SUBJECT: Lee County, US 421-NC 87, Sanford Bypass from west of SR  
1400 to west of US 1-15-501; Federal Aid Project STPNHF-  
421(2); WBS 34431.1.1; **TIP R-2417AA**

Attached are the modifications to the U.S. Army Corps of Engineers Section 404 Individual Permit and the NC DWQ Section 401 Certification. All environmental permits have been received for this project.

Subject: Action ID No. 2008-20899, TIP No. R-2417, US 421-NC 87 Sanford Bypass, Lee County, North Carolina.

North Carolina Division of Water Quality  
Transportation Permitting Unit  
In-Field Minor 401 Water Quality Certification, Buffer Certification and Isolated Waters Permit  
Modification

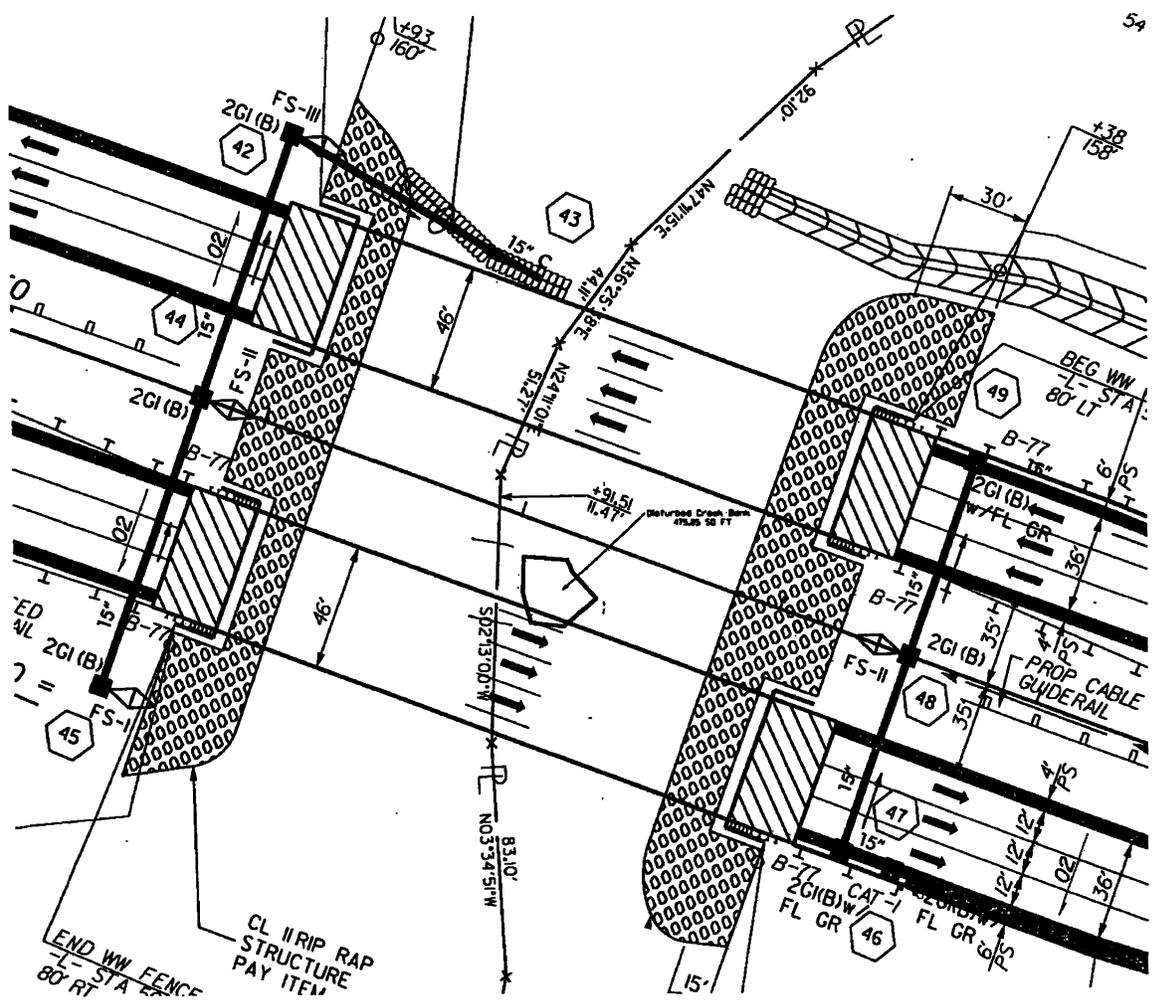
Permit site 4 [-L- 52408 (LT/RT)] Place Class I  
rip rap for bank stabilization along 25 ft of  
Big Buffalo Creek to repair bank washout that  
occurred during a heavy rain event on May 14, 2012.

Bank scour occurred where sediment basin discharged into creek during heavy rain event

Place rip rap along 25 ft of creek for bank stabilization to repair bank scour.

Procedure for repair of Streambank @ Buffalo Creek:

1. Place PCB (Portable Concrete Barrier) wrapped in filter fabric in existing stream channel to contain sediment and dewater site.
2. Remove sediment deposits within stream channel.
3. Excavate/Reshape existing streambank slope to allow for placement of Class 1 Rip Rap
4. Place Coir Fiber Material in excavated streambank section
5. Place Class 1 Rip Rap in area approx.. 2ft. thick.

Per attached map/plan sheets: Current disturbed area = 475.85 sq. ft.

*L = 25 FT*
